# IEEE 802.3da SPMD: MPoE: **Multiple MPIs per DTE**

Peter Jones, Cisco Systems  
May 2025

802.3da D2.2 defines LLDP TLVs for a single MPI per DTE. This document proposes changes to the current clause 30 and clause 79 draft text to support this/

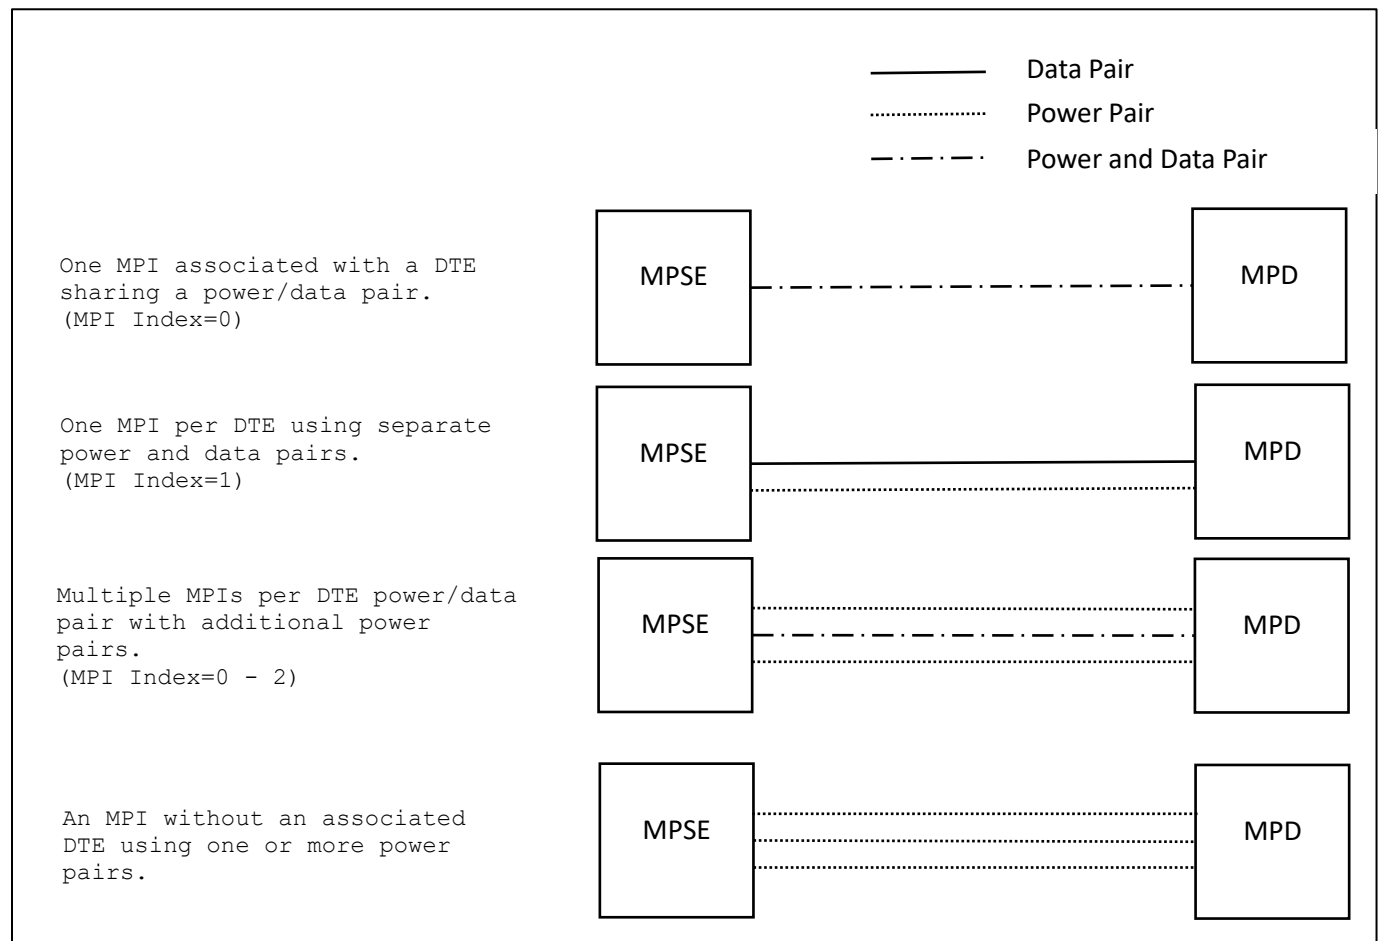
This proposal makes the following assumptions:

- All MPIs for a given DTE are either MPSEs, or MPDs.
- Unless stated otherwise, other MPI attributes for a given DTE are independent. This includes:
  - MPI type
  - MPI capabilities and status
  - MPI requested and granted power

The following diagram shows some examples (showing only two nodes for simplicity of drawing)

Figure 189-1a - Example MPI to DTE associations

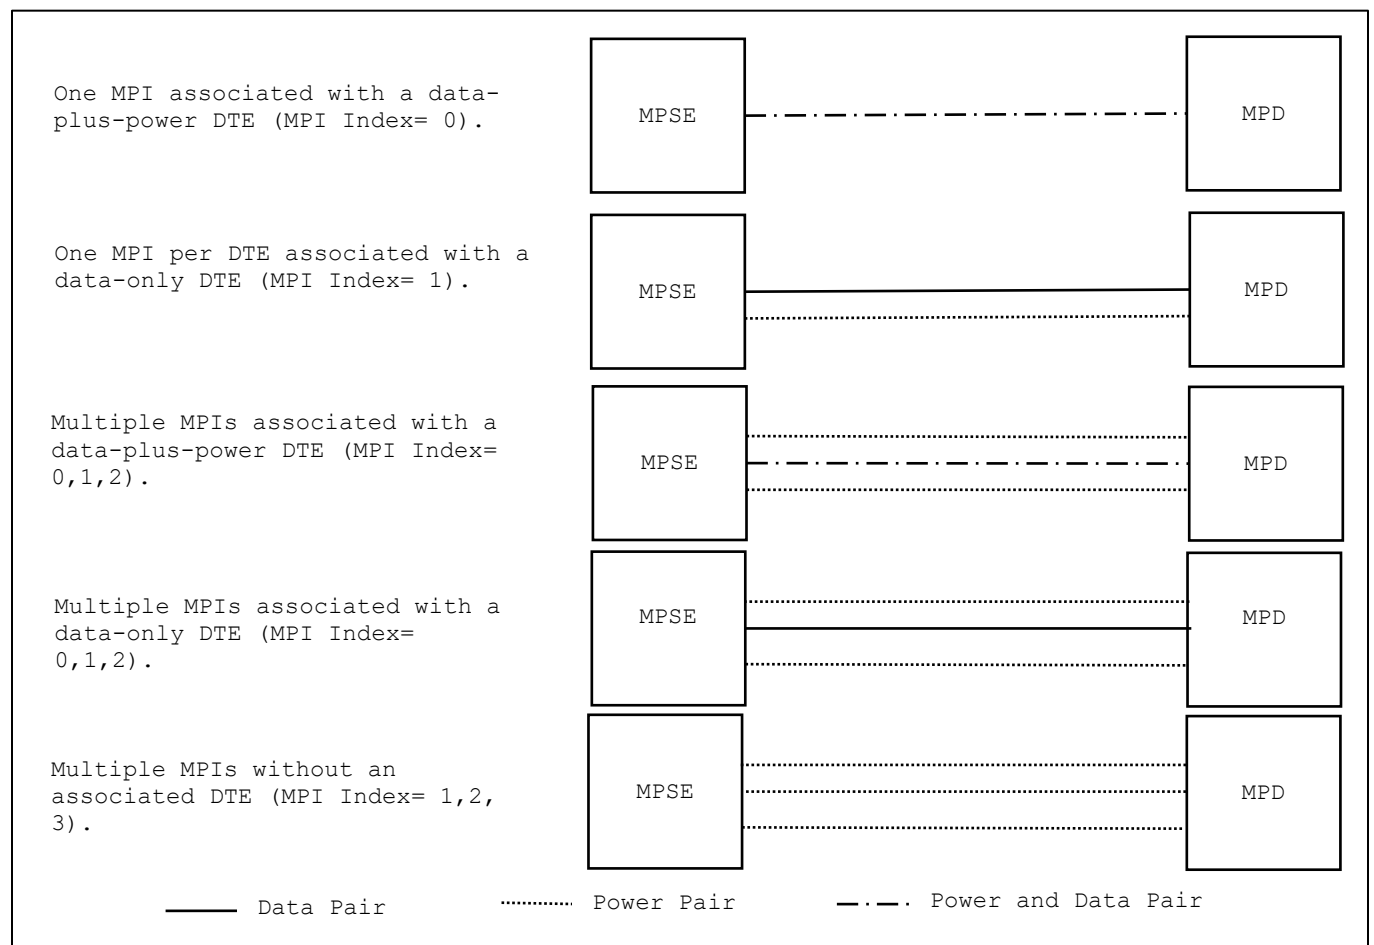
Add the following text after Figure 189–1 in 188.1.2

189.1.2a MPI and DTE association

Figure 189-1a below illustrates some of the different types of MPI and DTE associations supported by MPoE.

#### 189.1.2a.1 MPIs associated with a DTE

A DTE may be associated with 0, 1 or more than one MPIs. A DTE with 0 associated MPIs is a data only link. A DTE often has an MPI sharing the same power/data pair.

The set of MPIs associated with a DTE are identified within the DTE using an MPIIndex. MPIIndex has the following semantics:

- Type: 8 bit unsigned integer
- Values:
  - 0: The MPI that connects to the same physical media as the DTE.
  - >0: = separate MPIs

The set of MPIs associated with a DTE shall meet the following criteria:

- All MPIs for a given DTE are either MPSEs, or MPDs.
- Unless stated otherwise, all other MPI attributes for a given DTE are independent. This includes:
  - MPI type
  - MPI capabilities and status
  - MPI requested and granted power
